**REGULAR MEETING OF THE  
CITY OF CONCORD  
DESIGN REVIEW BOARD**

**Thursday, June 25, 2015  
5:30 p.m., Regular Meeting  
CITY COUNCIL CHAMBERS  
1950 Parkside Drive, Bldg. D**

**TO:** Design Review Board  
**FROM:** G. Ryan Lenhardt, Senior Planner  
**SUBJECT:** Golden State Lumber (PL131301 - DR)

**SUBJECT:** Site Design, Orientation, and Location of Buildings for Potential 18-Lot Subdivision Study Session – Request for Feedback

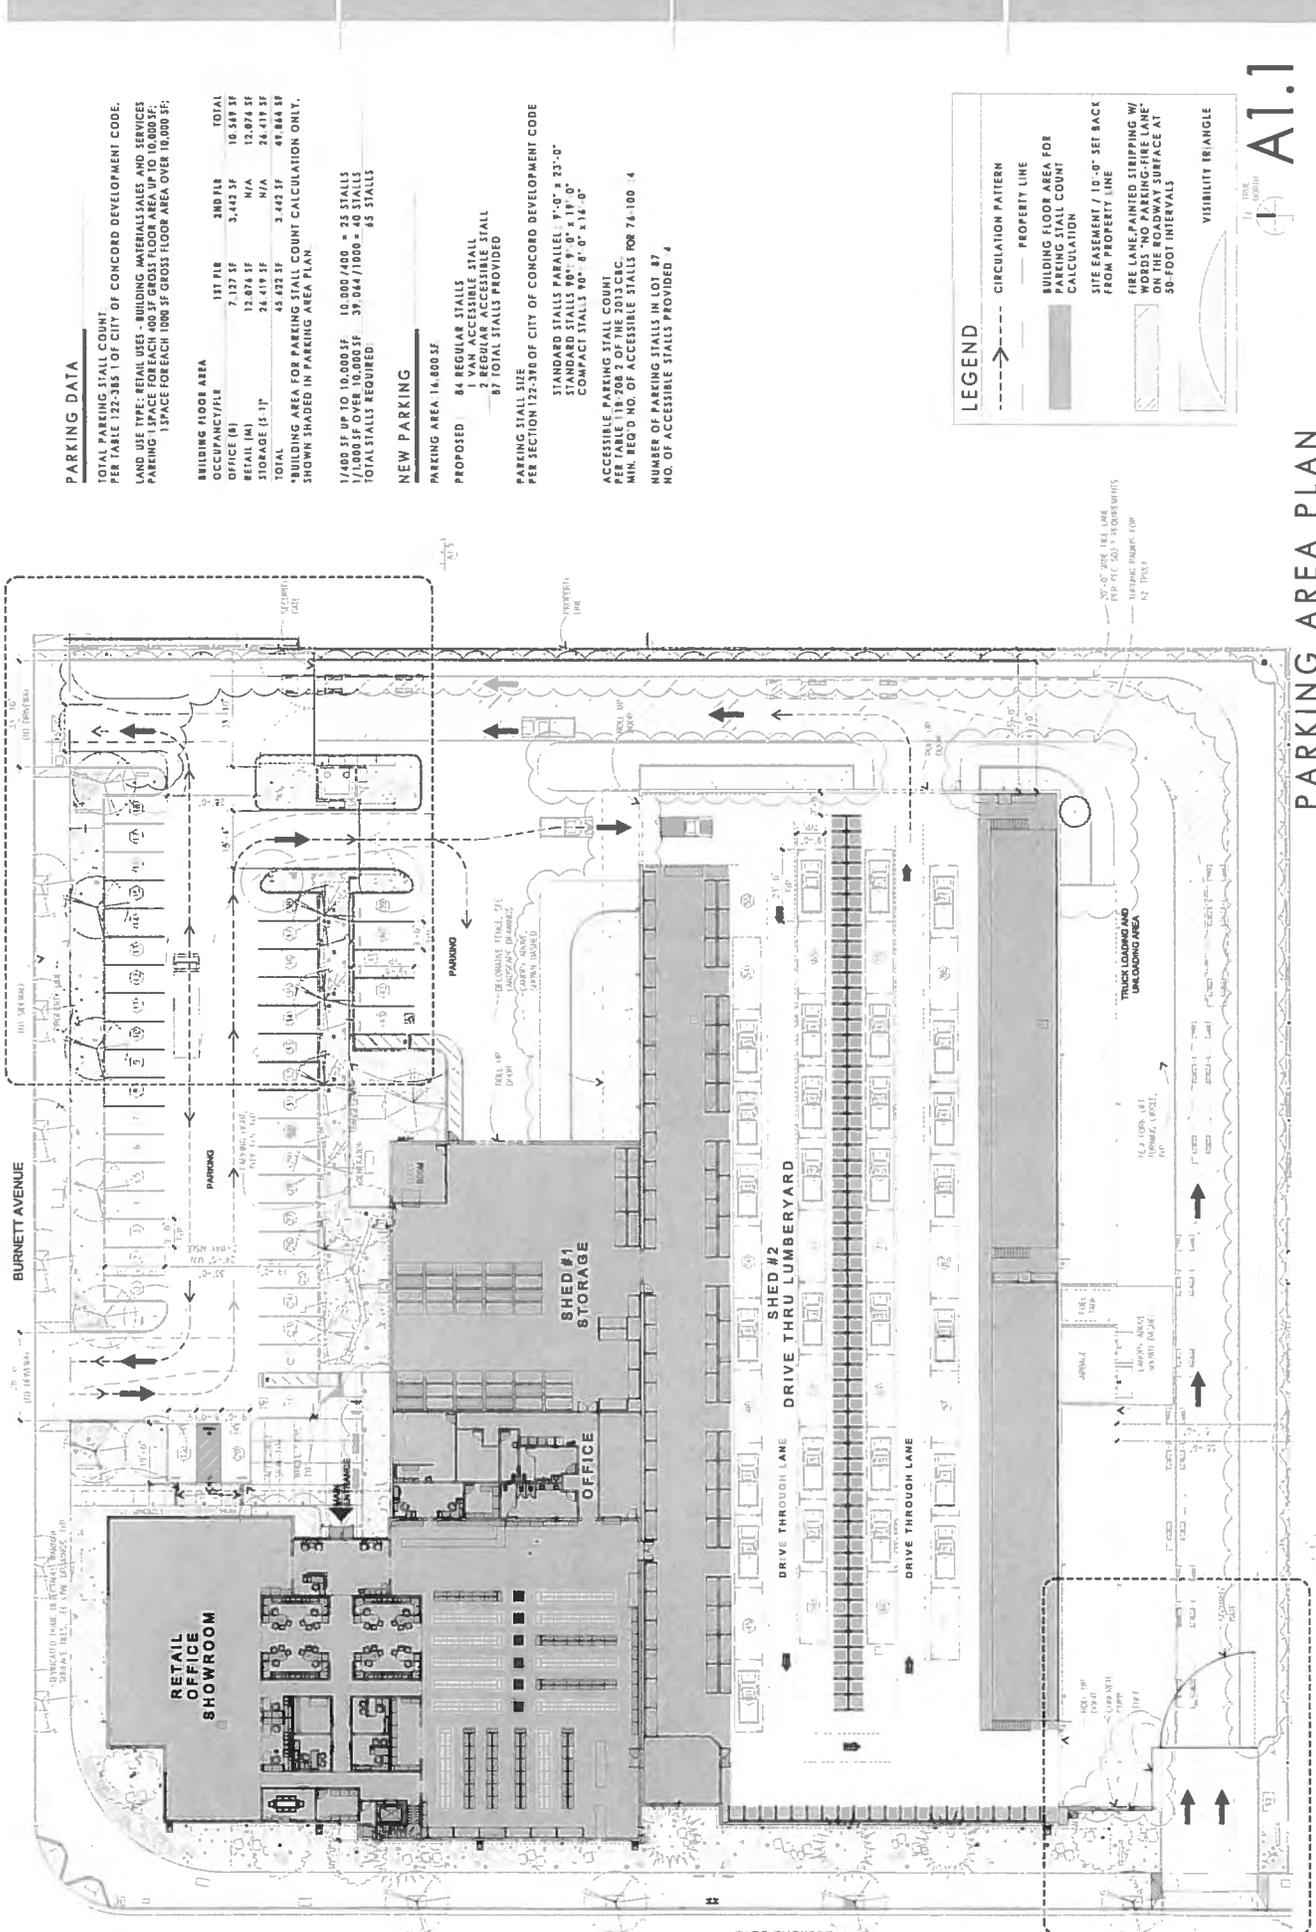
1. Updated site plan to include over 20% landscape coverage. (A1.2, L-1, L-3.2)
2. Removed truck depression loading dock. (A1.1)

3. Removed wall and railing that separated the parking area from the truck depression loading dock. (A1.1)
4. Reduced the depth of the canopy from 36'-5" deep to 12' deep over the former truck depression area/ north side of shed #2/drive thru lumberyard. (A3.01, A3.02)
5. Reduced the length of the canopy by 16' on the south side of shed #2/drive thru lumberyard. (A3.02)
